01 November 2024

Subject: Valley of the Winds - Amendment Letter

ACEN Australia (ACEN) seeks to provide the Department of Planning, Housing and Infrastructure (DPHI) with the following amendment to the Valley of the Winds (VOW) Project, SSD-10461.

Figure A2-1 | Overview of project refinements

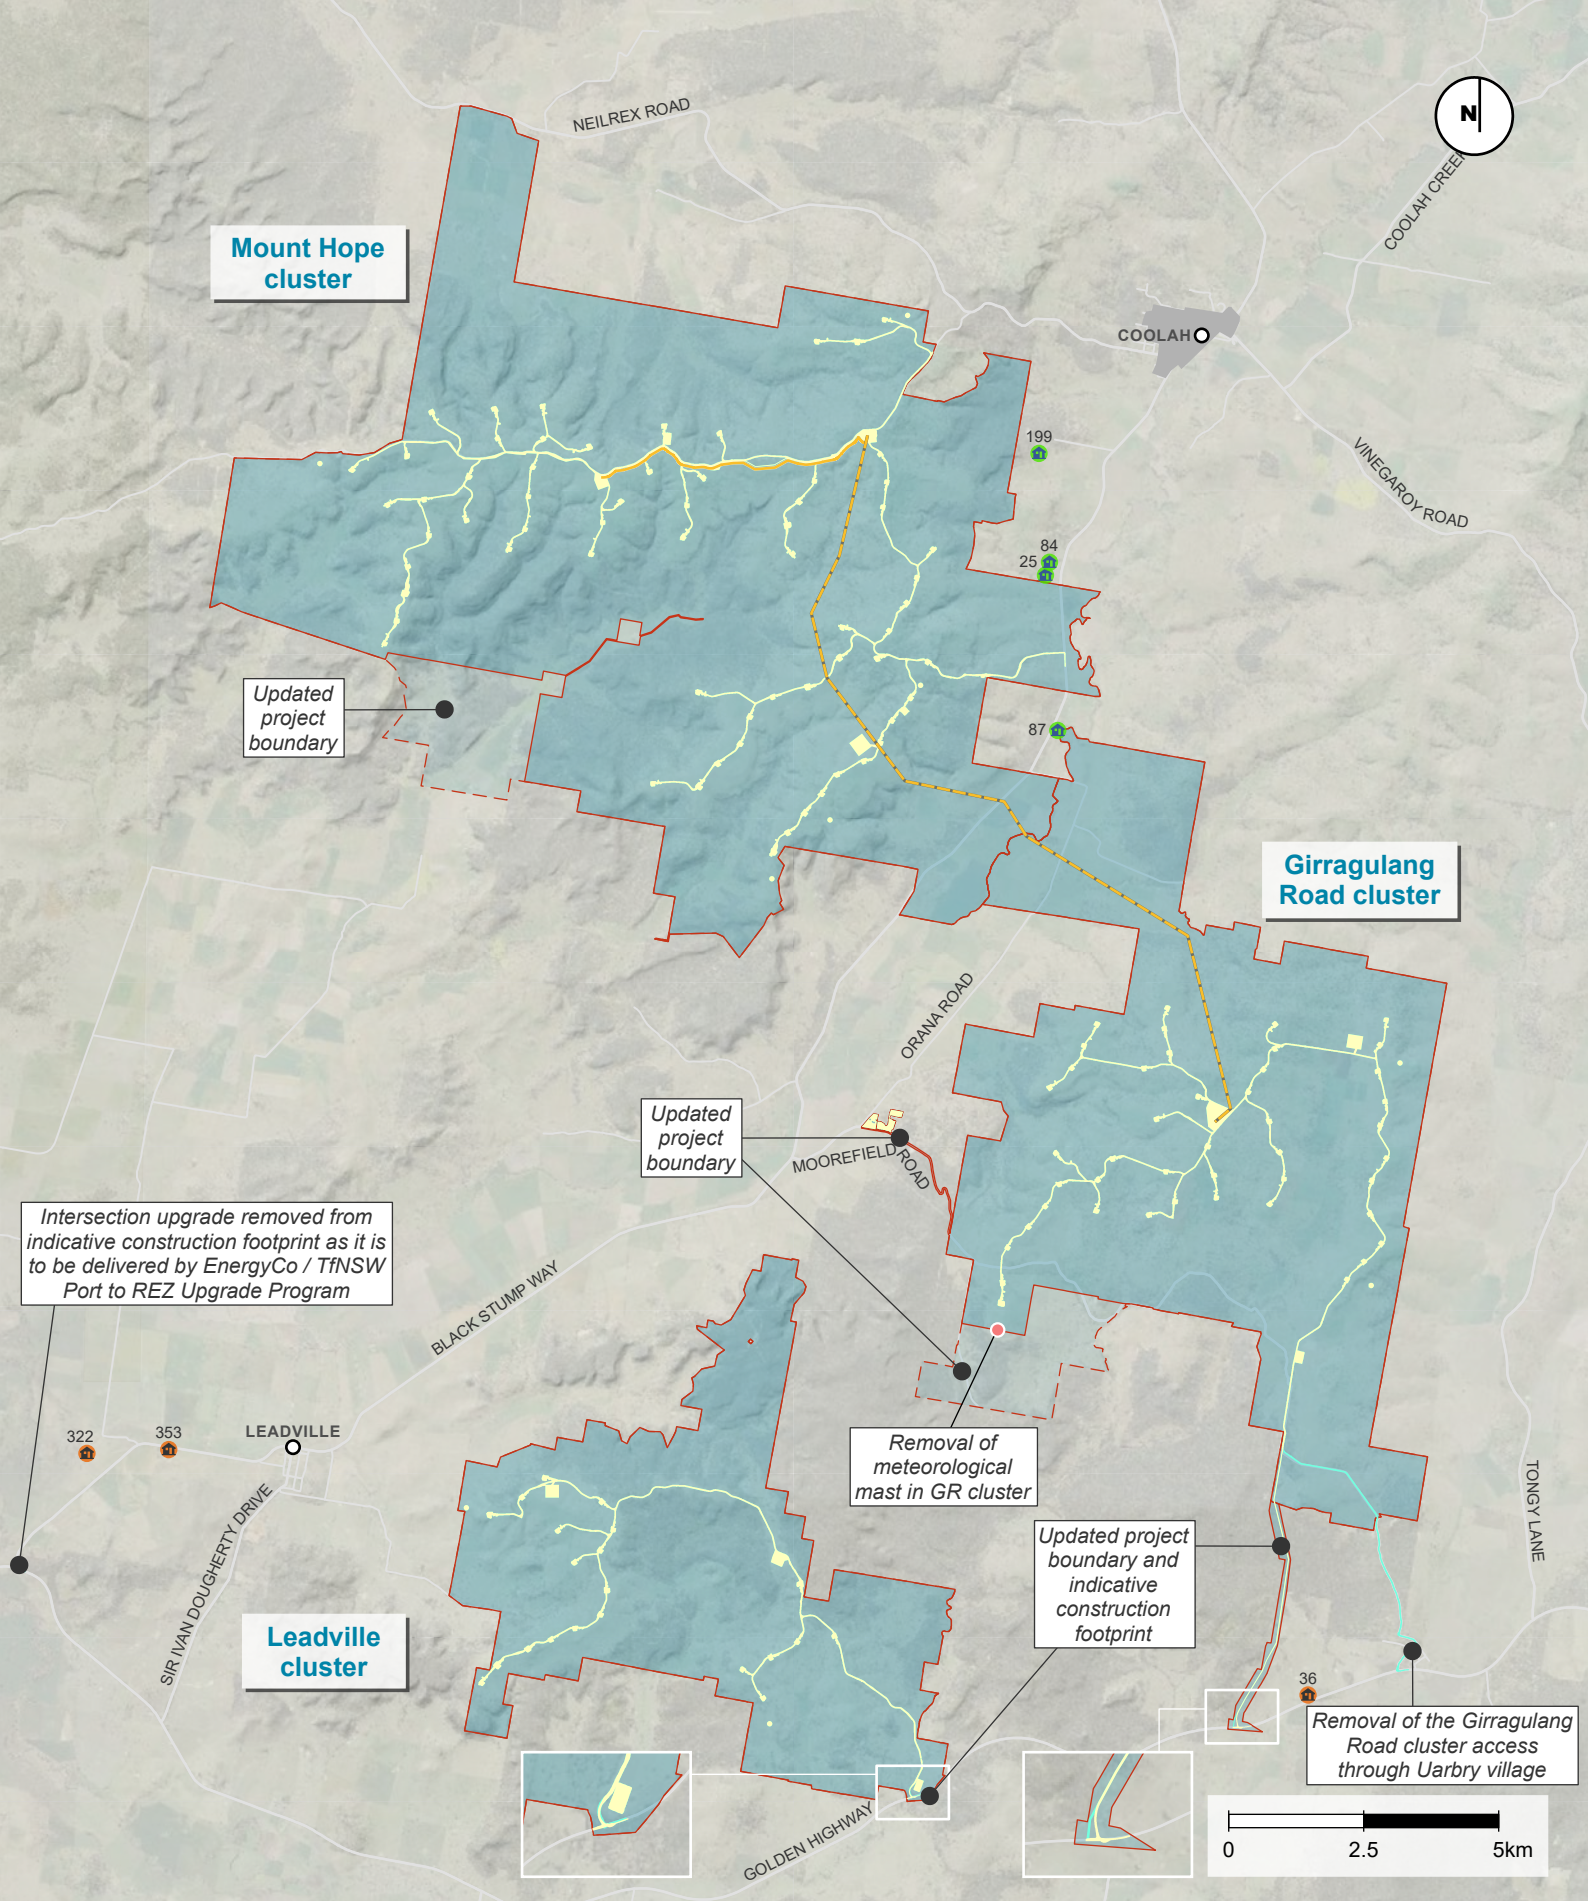
The proposed Project amendments are presented in the **Project Amendments Figure** in Attachment 2 and include:

- Removal of the access through Uarbry Village to the Girragulang Road Cluster. No access is now proposed through Uarbry Village
- Updates to the Project Site, Development Corridor and Indicative Construction Impact Footprint to:

- remove the Girragulang Road cluster access through Uarbry Village (which include, Short Street, Turee Street, Main Street and Wyaldra Street, Moorefield Road [east])

- include the updated intersection design for the Preferred access to Girragulang Road cluster on the Golden Highway (approx. 3km west of Uarbry)
 - include the updated intersection design for the Leadville cluster on the Golden Highway

- include the Moorefield Road (west) road to accommodate light vehicle access to/from the temporary workforce accommodation facility
 - removal of unutilised areas of private landholdings

- Removal of meteorological mast in the Girragulang Road cluster
- Removal of the intersection upgrade for the Black Stump Way/Golden Highway intersection (to be delivered by EnergyCo / TfNSW Port to Renewable Energy Zone (REZ) Upgrade Program)

Figure A3-1 | Project overview

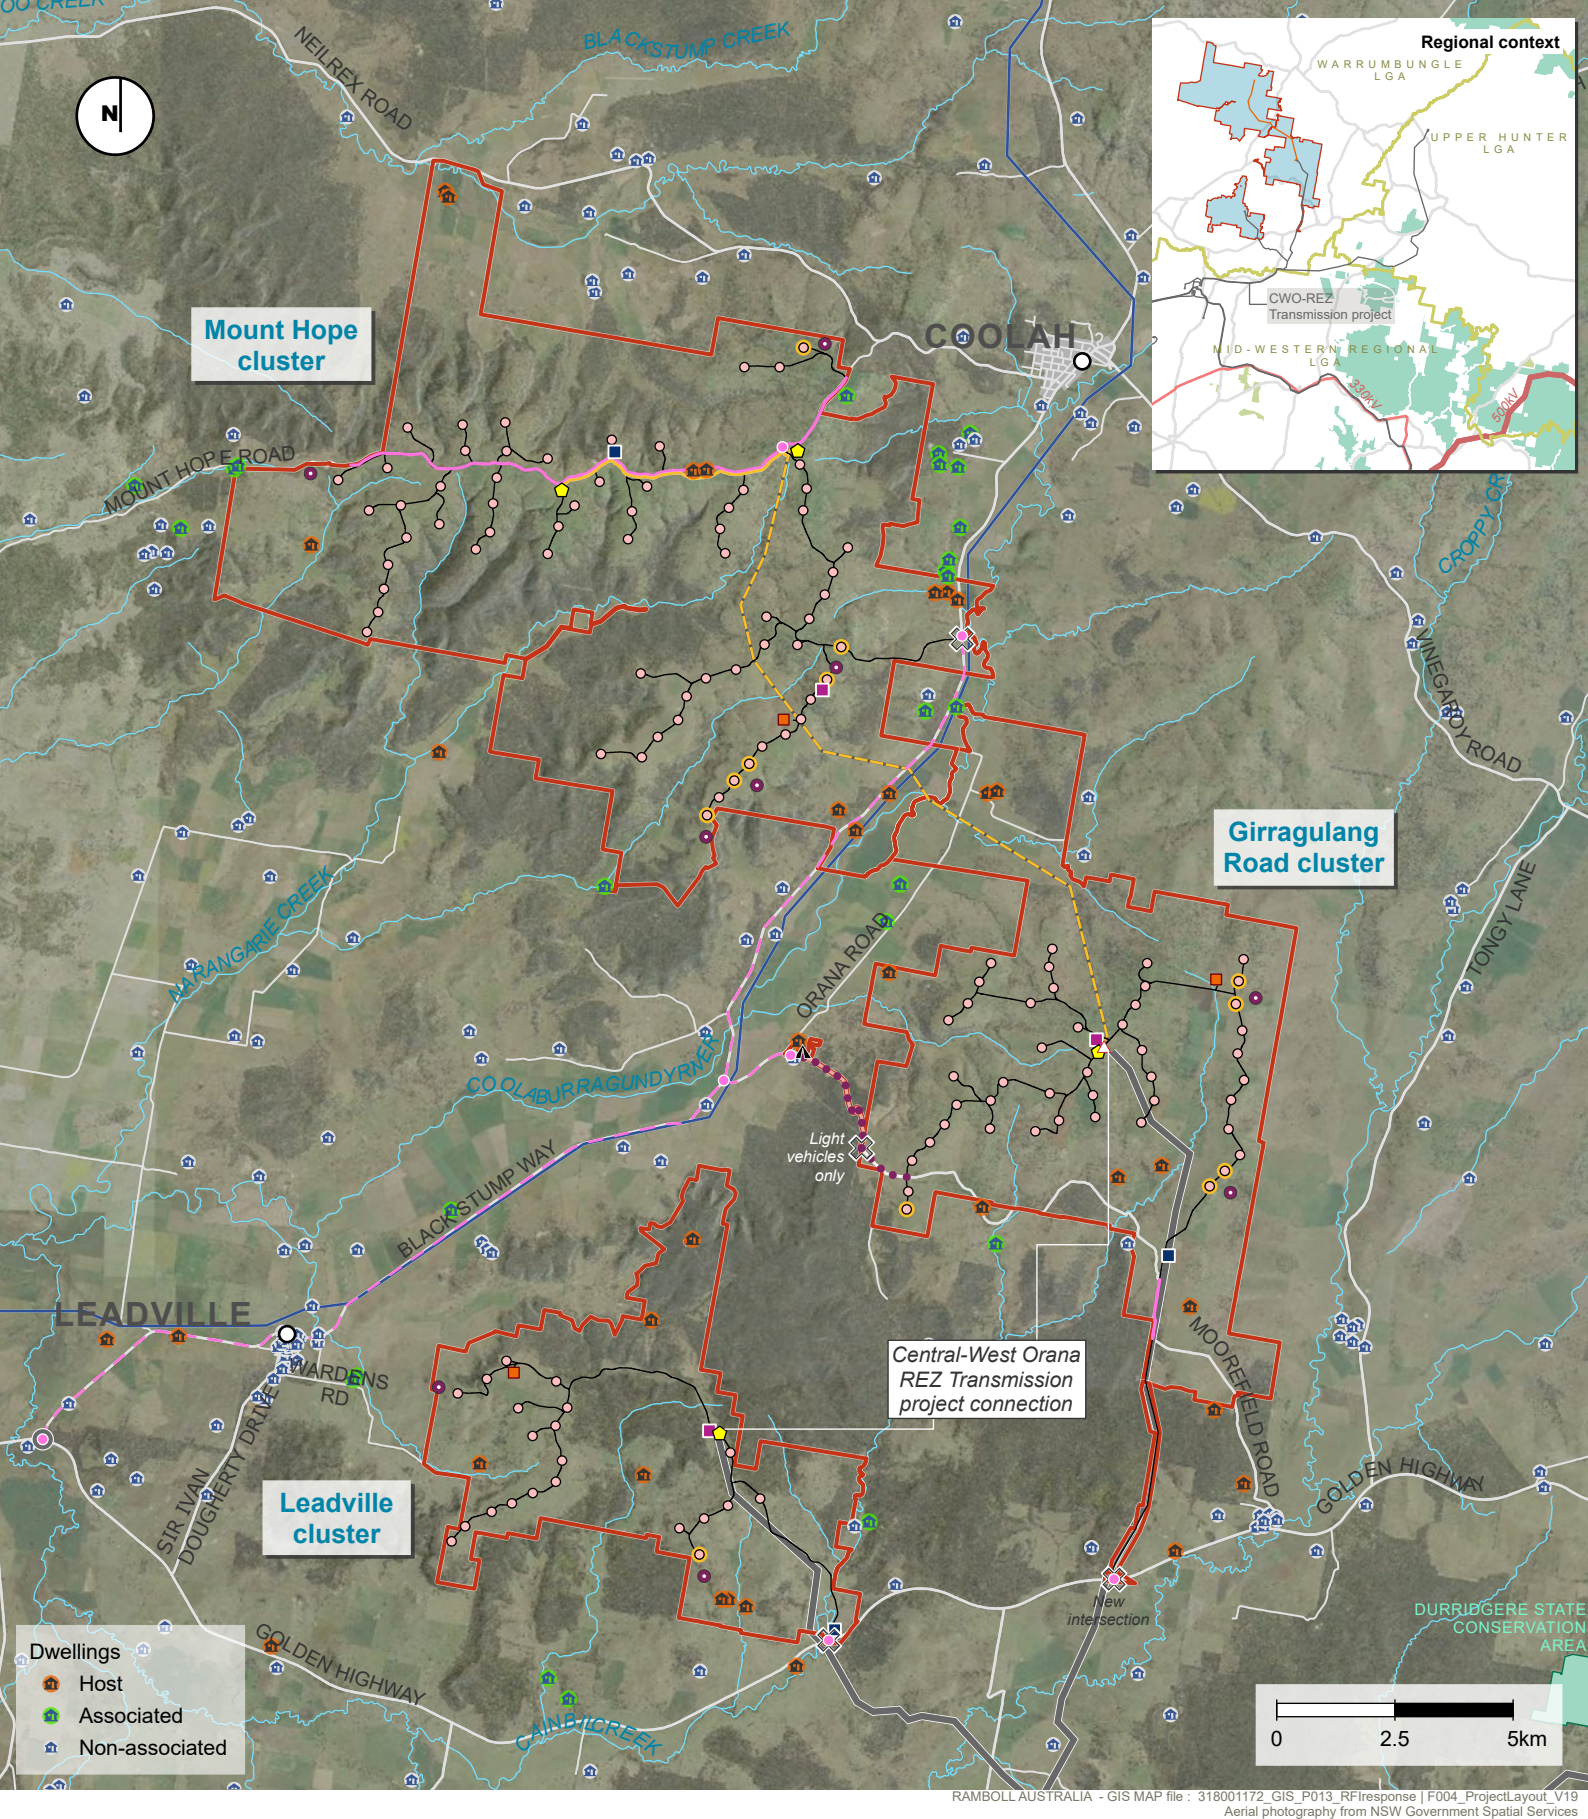
The proposed **Project Amendments Figure** is presented in Attachment 2, and the **Revised Project Layout Figures** are provided in Attachment 3.

Additionally, the **Revised Project Layout Figures** provide clarification on the location of the underground section of transmission line (up to 330kV) in the Mount Hope cluster, the connection points to the CWO-REZ Transmission project (SSI 48323210) (EnergyCo), and the location of an existing gas pipeline.
